## **MUKILTEO FERRY TERMINAL (PHASE 2) FERRY TERMINAL CONSTRUCTION**

VOLUME 2 OF 8

VOLUME 2 SHEET INDEX

C09.10  
SHEET  
228  
OF  
1521  
SHEETS

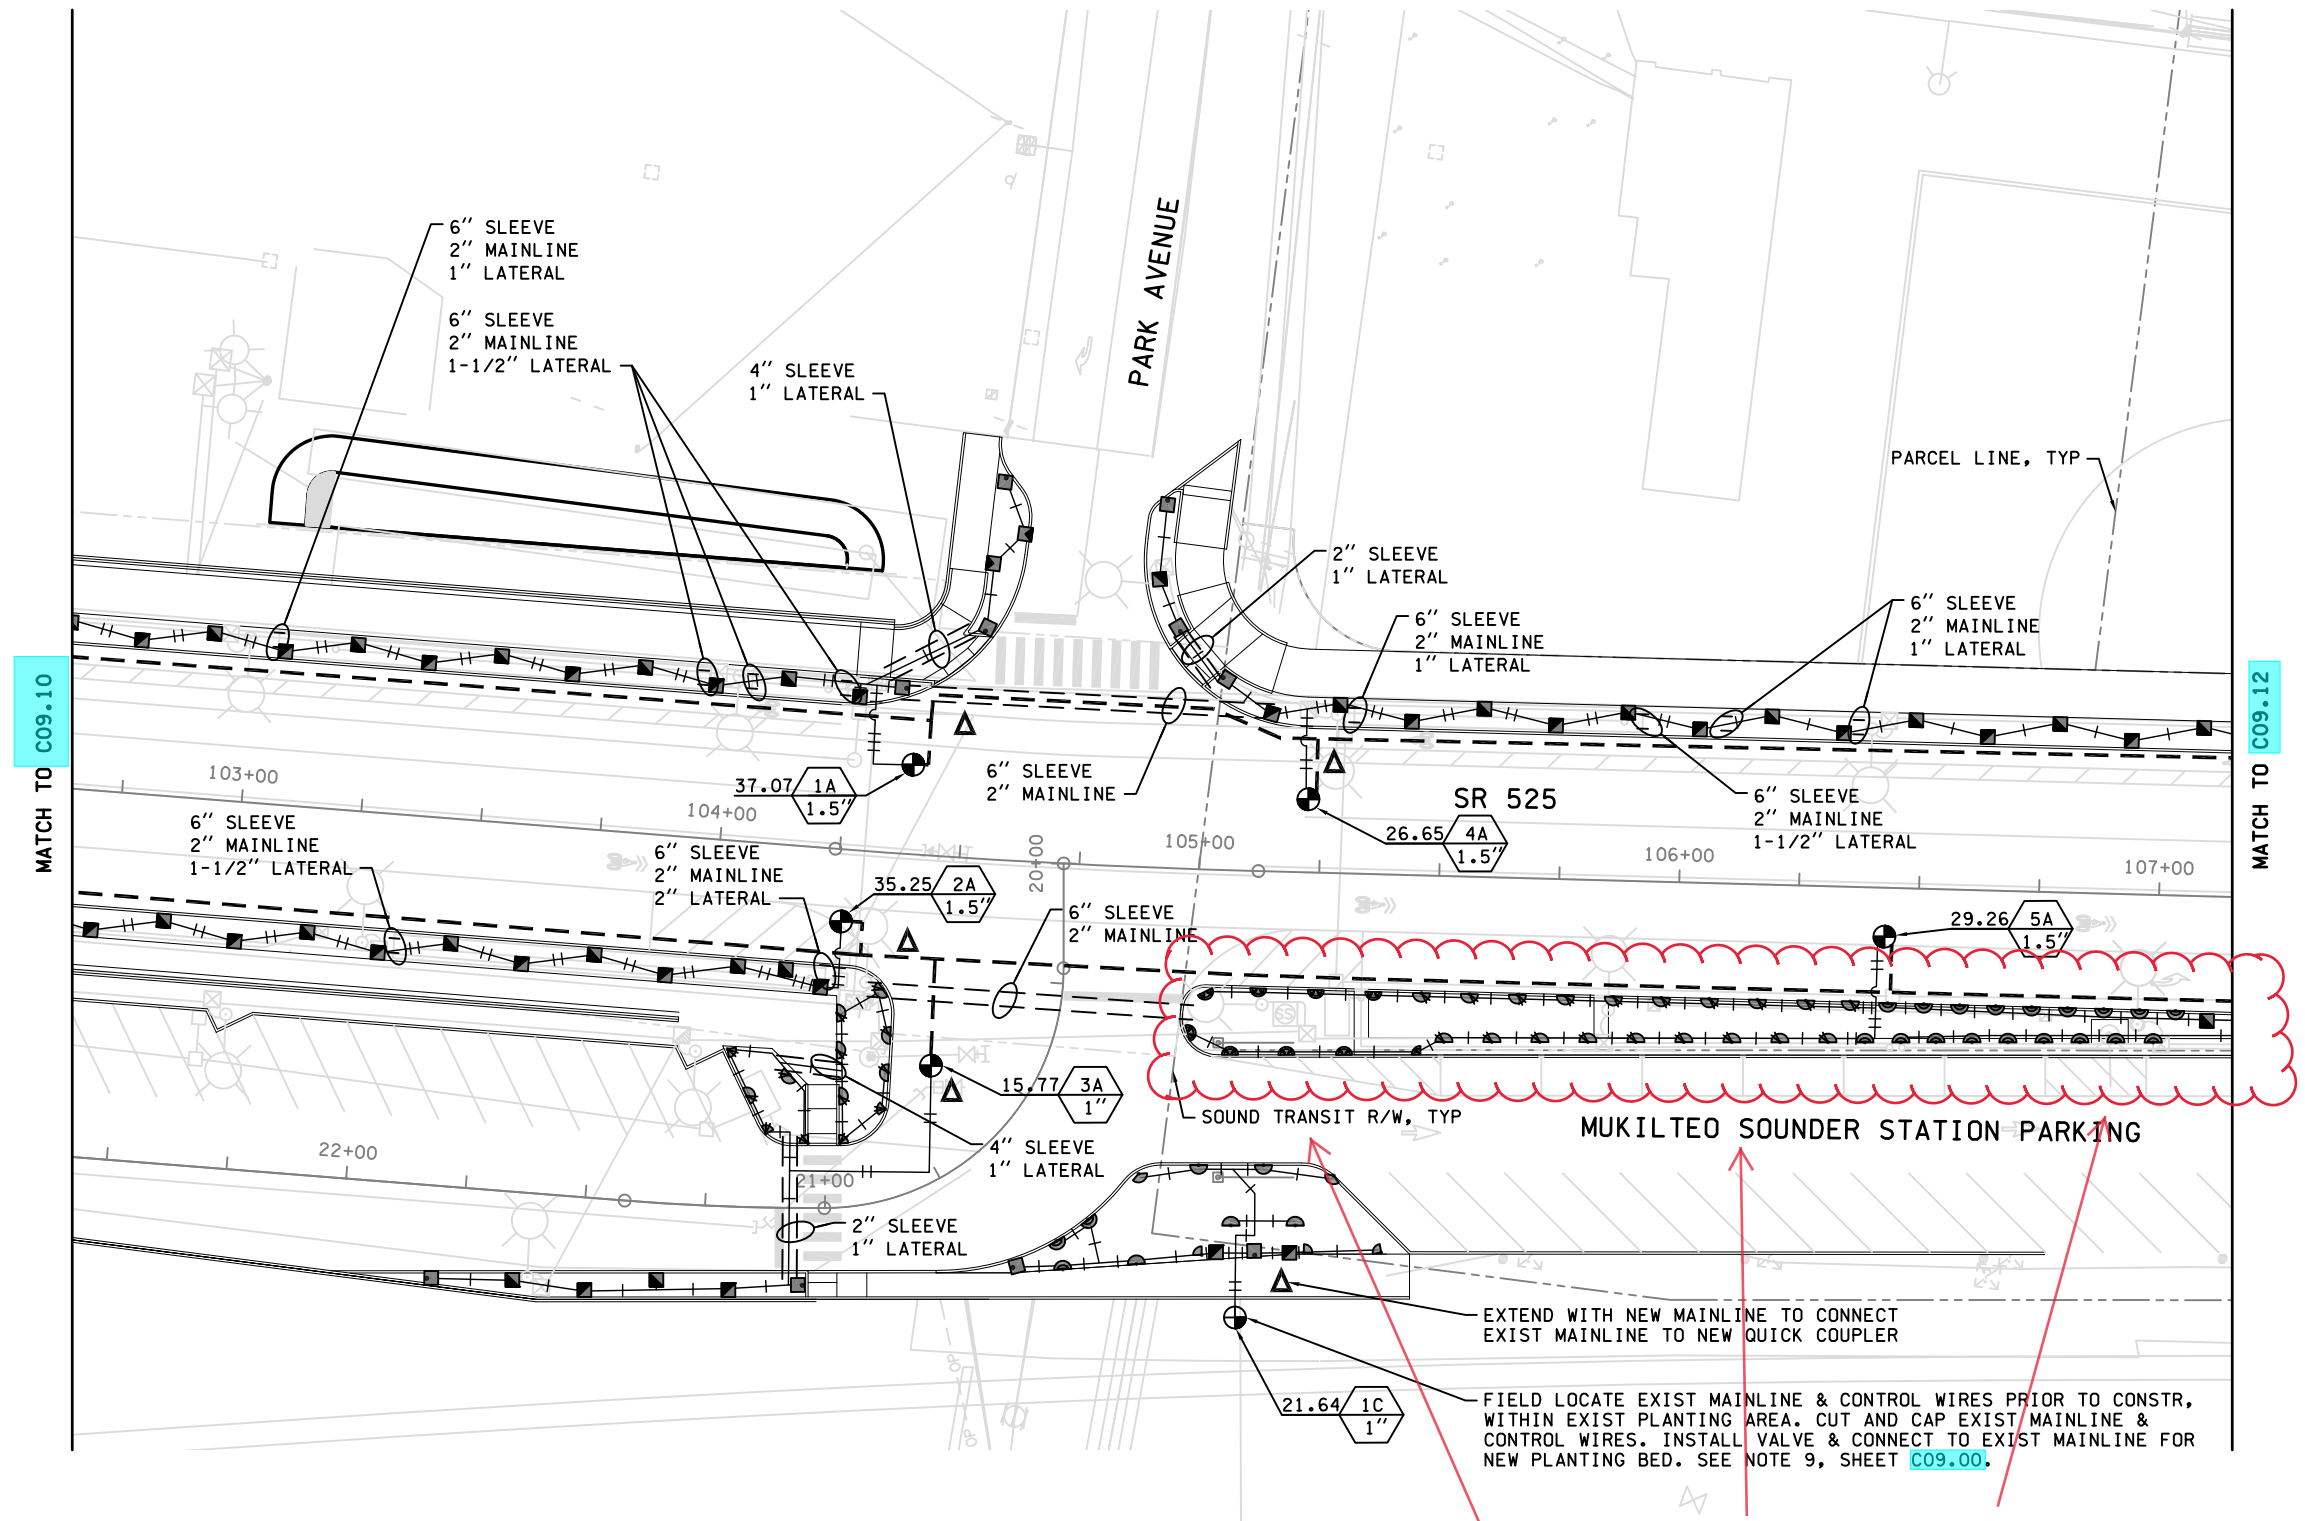
RFI - 622 - Irrigation Heads wont fit on the South side of planter

Adjust the southern portion of the irrigation within planting C00.11 and C09.12 to avoid drainage pipe and geotextile by shifting irrigation north.

C09.11  
SHEET  
229  
OF  
1521  
SHEETS

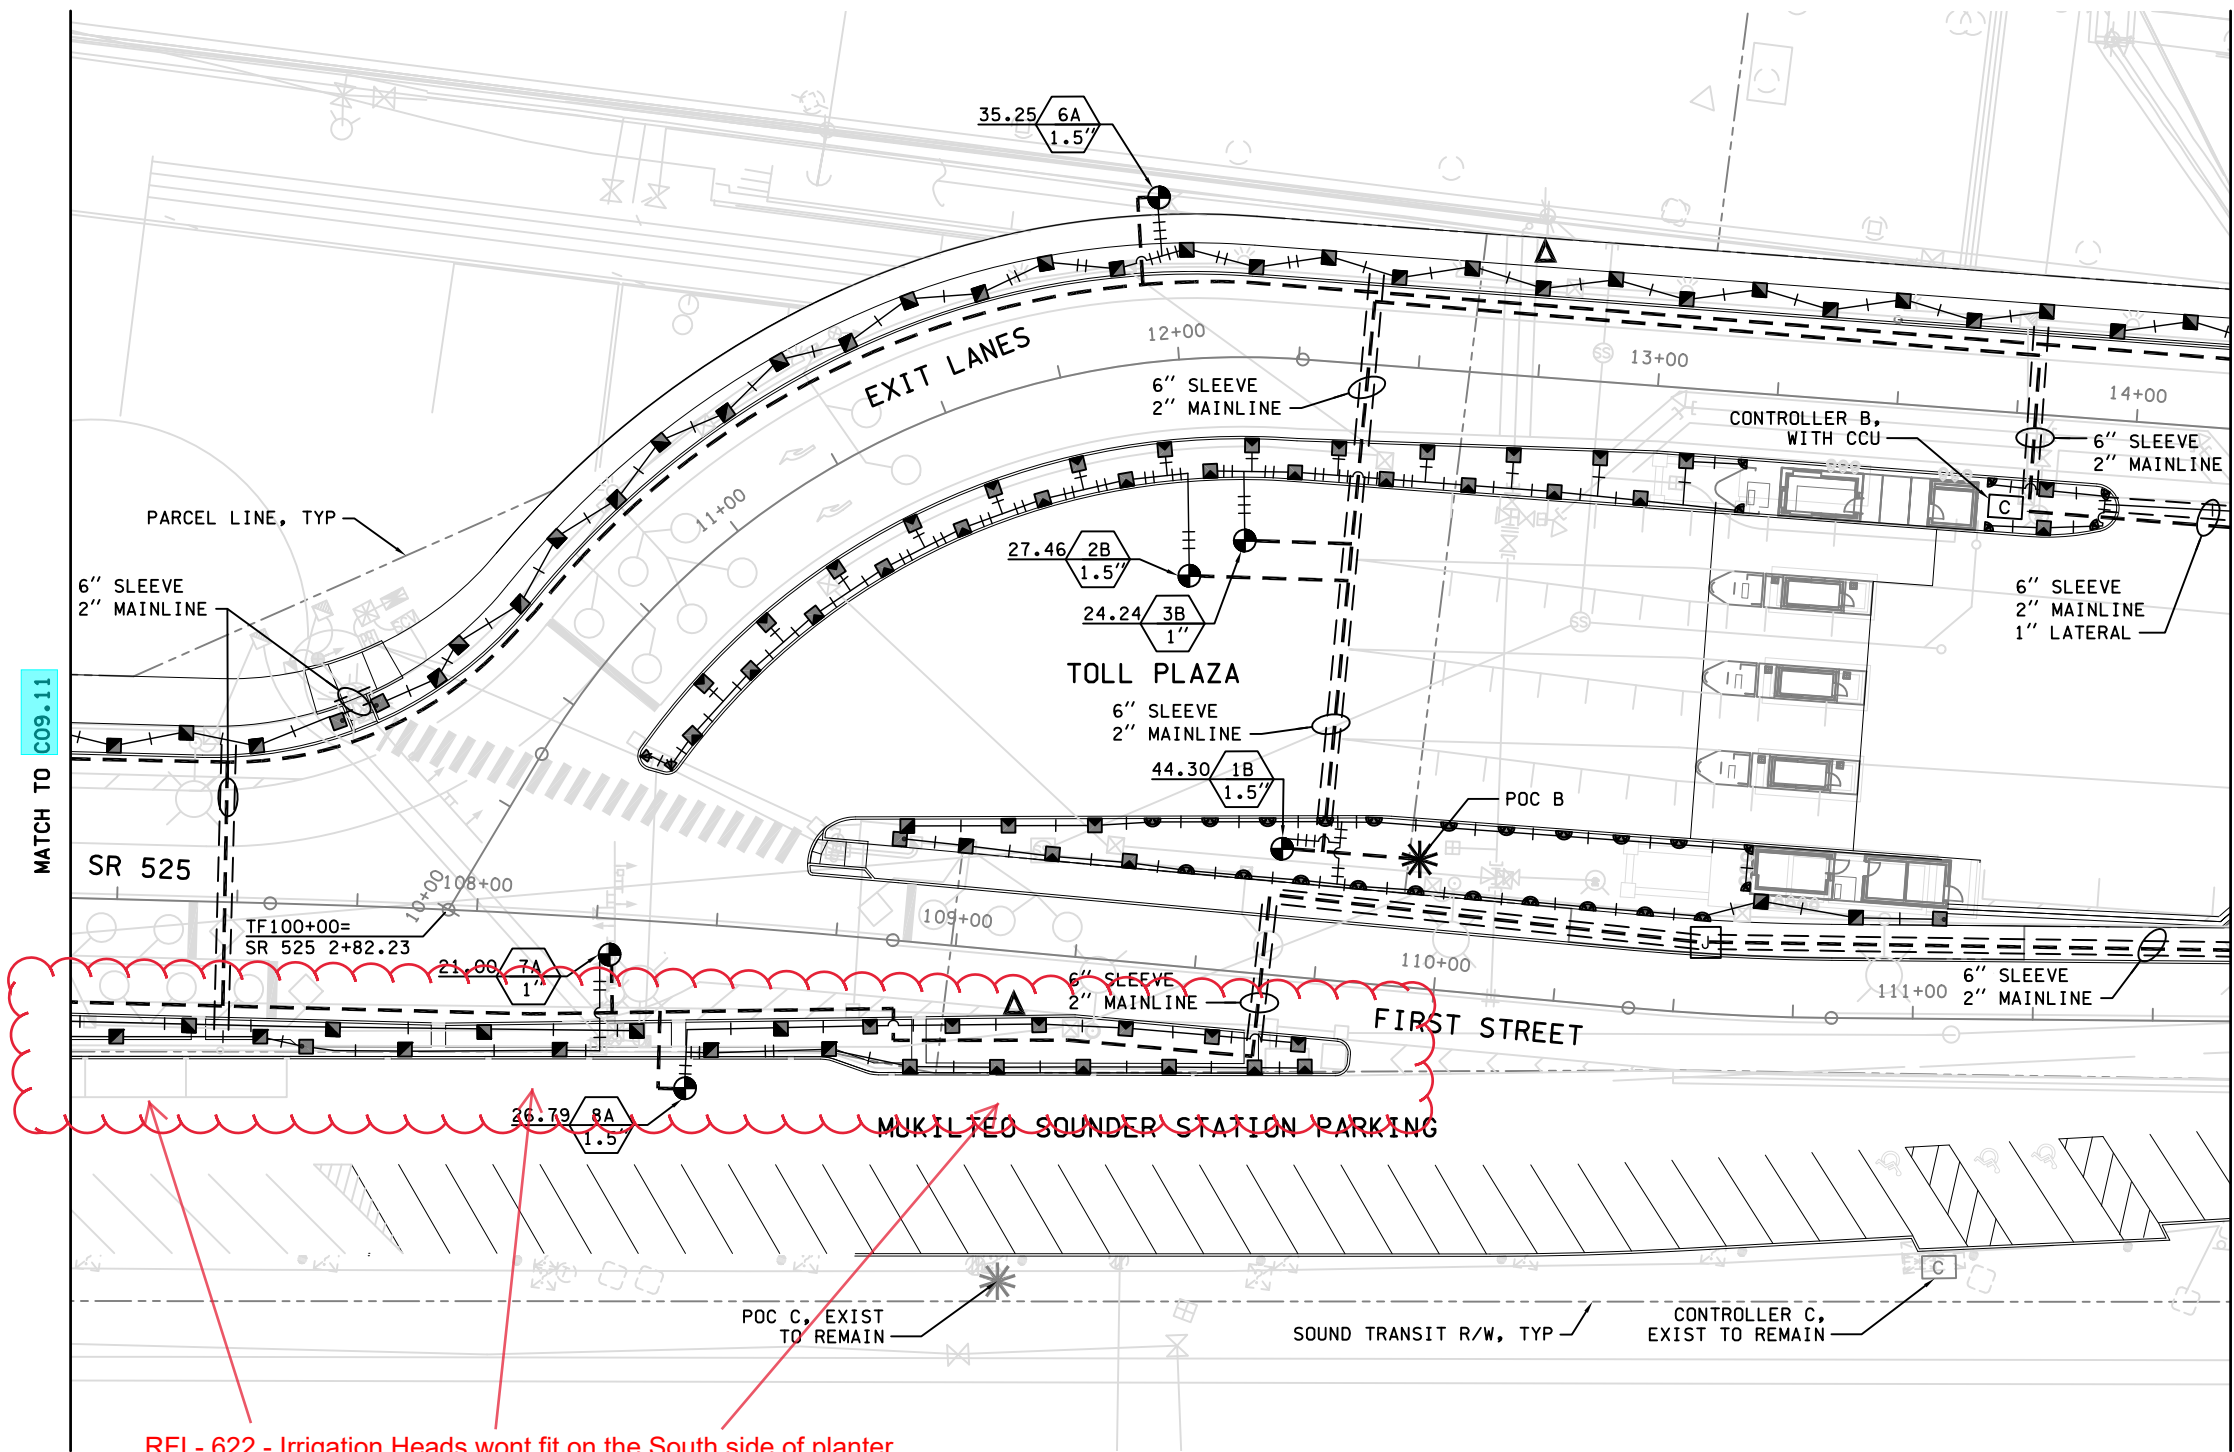
RFI - 622 - Irrigation Heads wont fit on the South side of planter

RESPONSE:  
Adjust the southern portion of the irrigation within planting C00.11  
and C09.12 to avoid drainage pipe and geotextile by shifting irrigation north.

C09.12  
SHEET  
230  
OF  
1521  
SHEETS

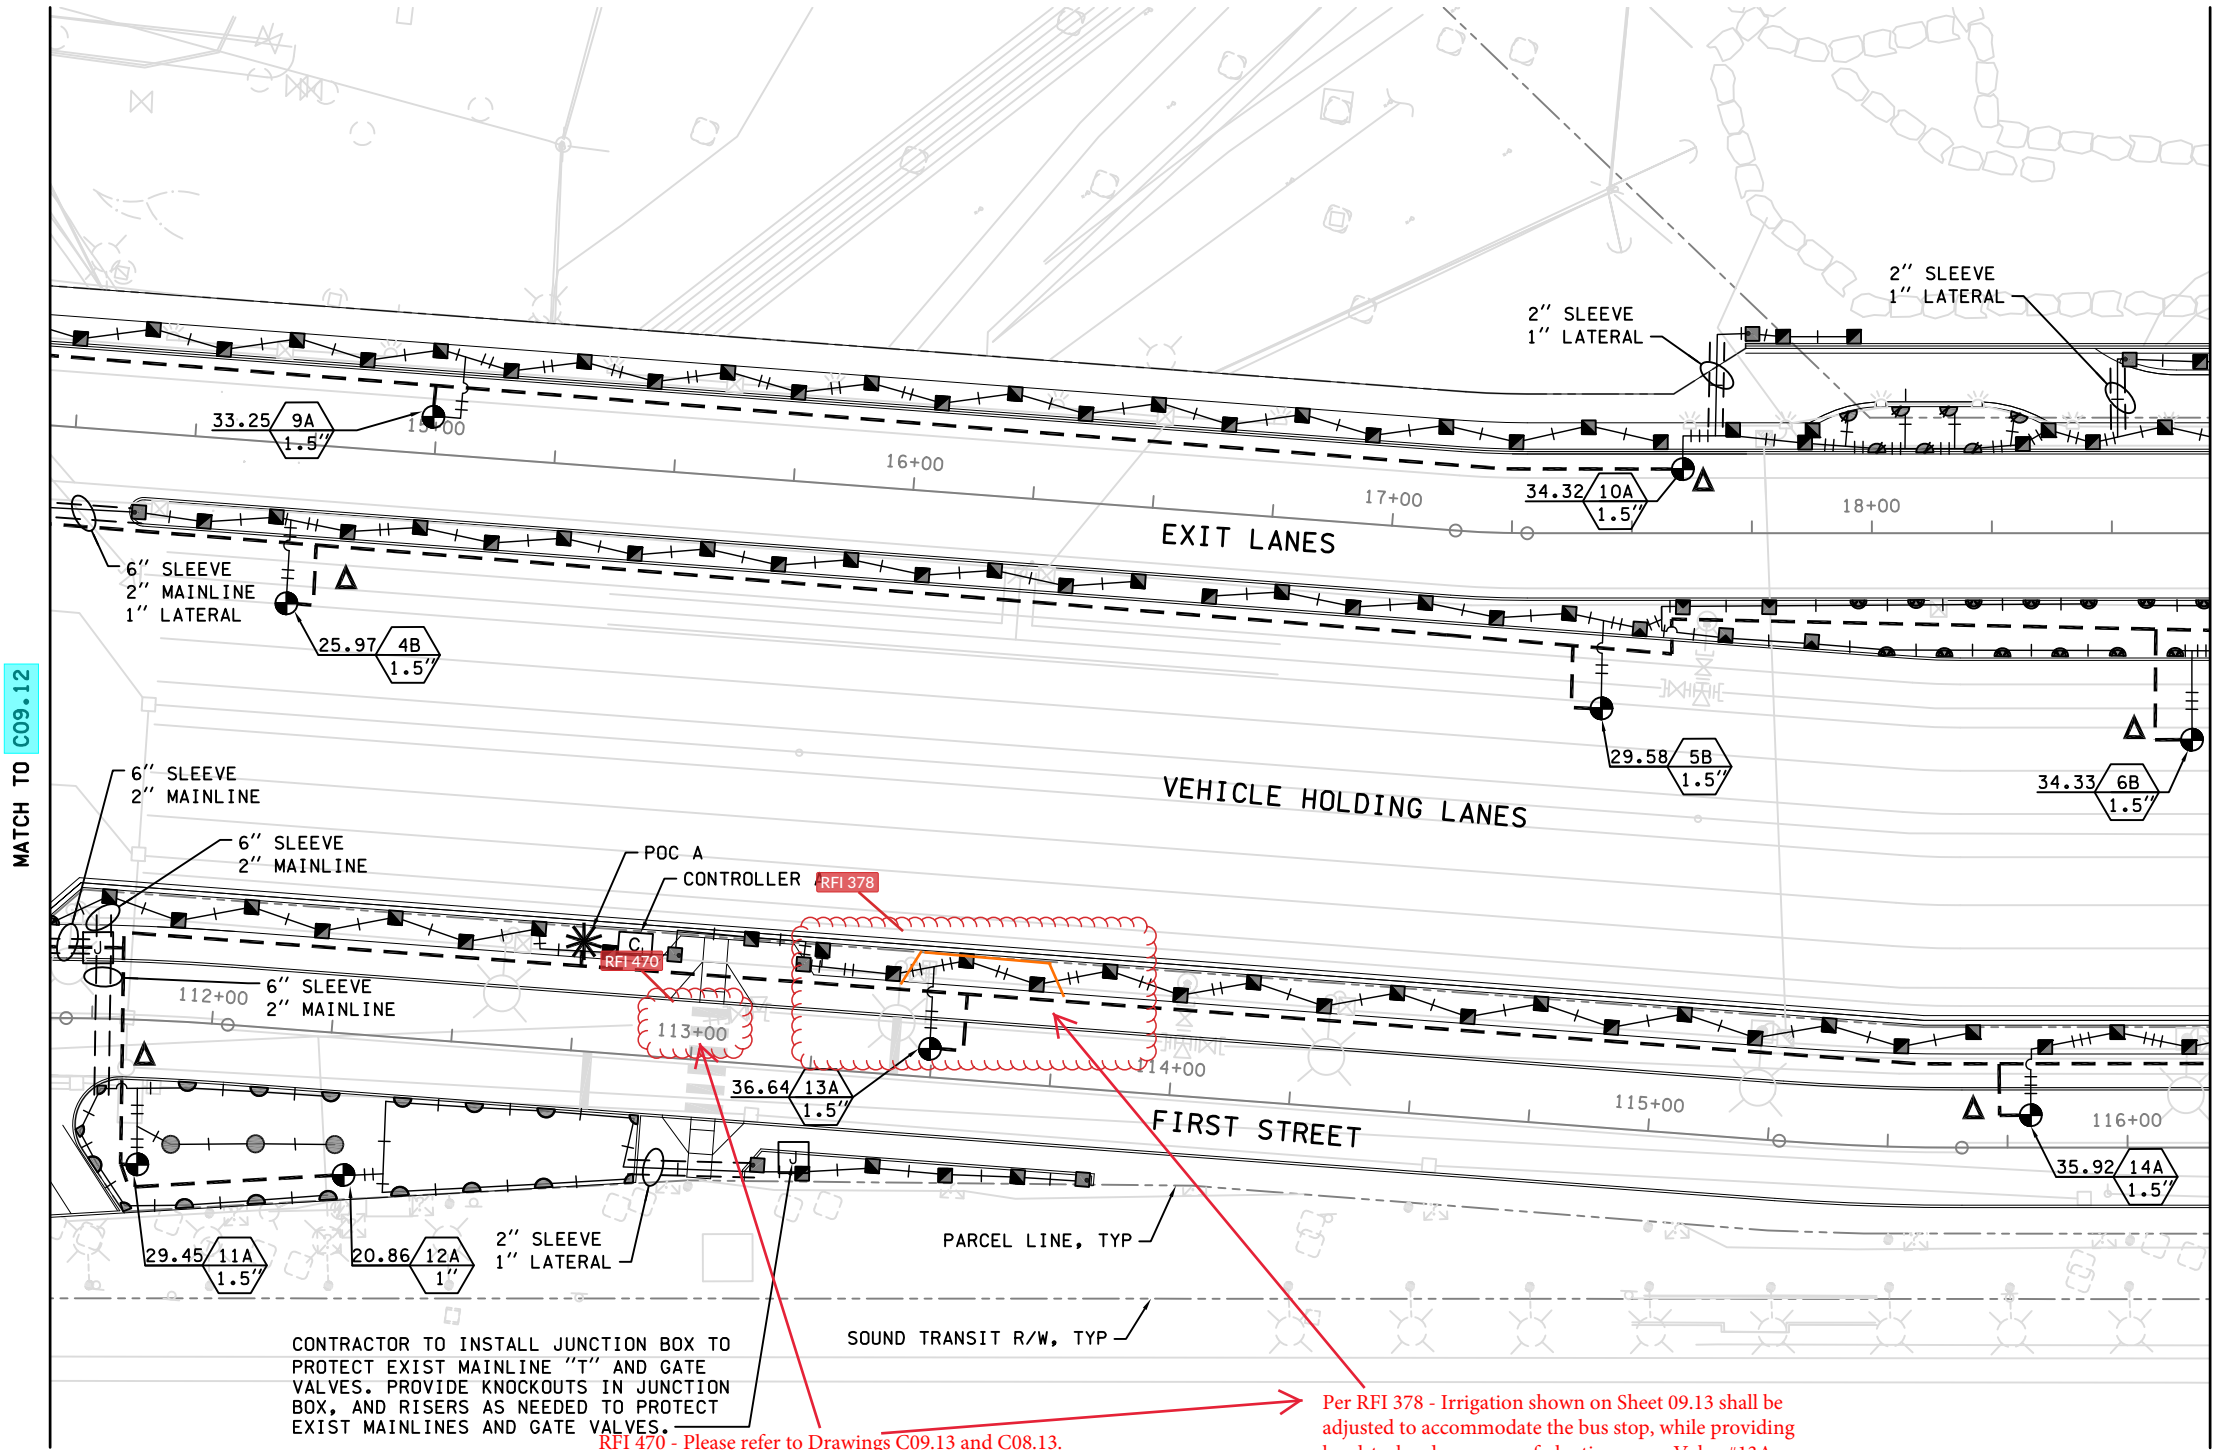
RFI 470 - Please refer to Drawings C09.13 and C08.13. The Point of Connection A for the Irrigation System on C09.13 does not align with the 2" Irrigation Water SVC on C08.13 (TF 113+48.19 (22.80L)). IMCO proposes to run a pipe from the 2" Irrigation Water SVC to their point of connection A. Please confirm if this is acceptable  
RESPONSE:  
No exceptions - Contractor to coordinate with RFI 378

Per RFI 378 - Irrigation shown on Sheet 09.13 shall be adjusted to accommodate the bus stop, while providing head-to-head coverage of planting areas. Valve #13A shall be relocated to be within planting areas. Additional sleeves will be required for the mainline and lateral line to run underneath the bus stop. Note that the Point of Connection A (POC A) equipment associated with this irrigation meter.
